SUBJECT: ORDER FOR MODIFICATION OF LICENSE CONCERNING PRIMARY COOLANT
SYSTEM PRESSURE ISOLATION VALVES

In the Matter of
JERSEY CENTRAL POWER & LIGHT CO.
(Oyster Creek Nuclear Generating
Station)

ORDER FOR MODIFICATION OF LICENSE

SAFETY EVALUATION REPORT
OYSTER CREEK NUCLEAR GENERATING STATION
PRIMARY COOLANT SYSTEM PRESSURE ISOLATION VALVES
(WASH-1400, EVENT V)

Figure 1. Valve Configurations Designated by the NRC To Be Included in This Technical Evaluation

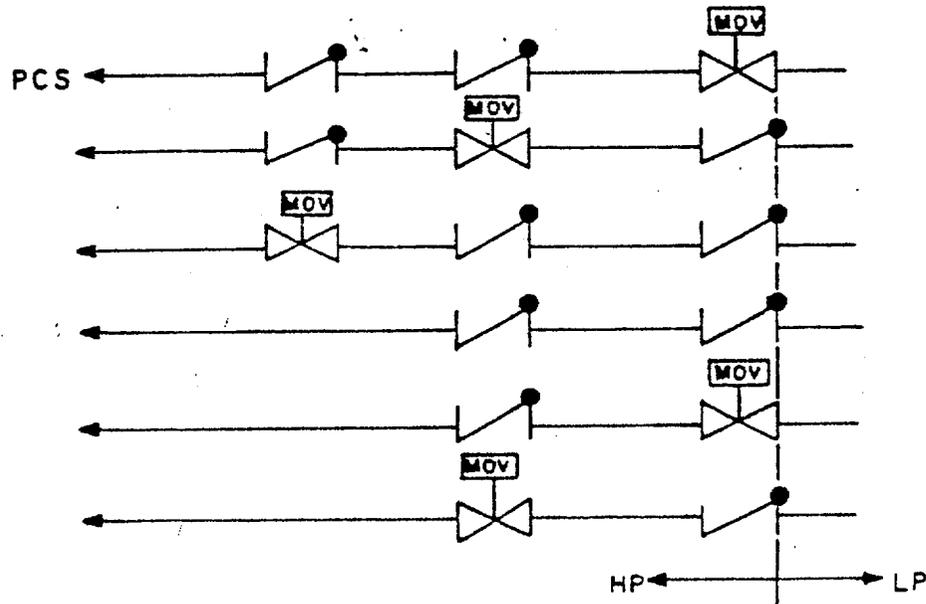
For a piping system to have a valve configuration of concern, the following five items must be fulfilled:

- 1) The high-pressure system must be connected to the Primary Coolant System;
- 2) there must be a high-pressure/low-pressure interface present in the line;
- 3) this same piping must eventually lead outside containment;
- 4) the line must have one of the valve configurations shown in Figure 1; and
- 5) the pipe line must have a diameter greater than 1 inch.

Based on the previously docketed information and drawings made available for FRC review, FRC found that loops A and B of the Core Spray System in Oyster Creek Unit 1 contain a valve configuration of concern (identified in Figure 1). Thus, if the licensee's review of the valving configuration contained in the loops A and B of the Core Spray System confirms FRC's finding, then the valve configurations of concern existing in Oyster Creek Unit 1 incorporate the valves listed in Table 1.0.

If JCP modifies the Plant Technical Specifications for Oyster Creek Unit 1 to incorporate periodic testing (as delineated in Section 2.2) for the check valves itemized in Table 1.0, then FRC considers this an acceptable means of achieving plant compliance with the NRC staff objectives of Reference 1.
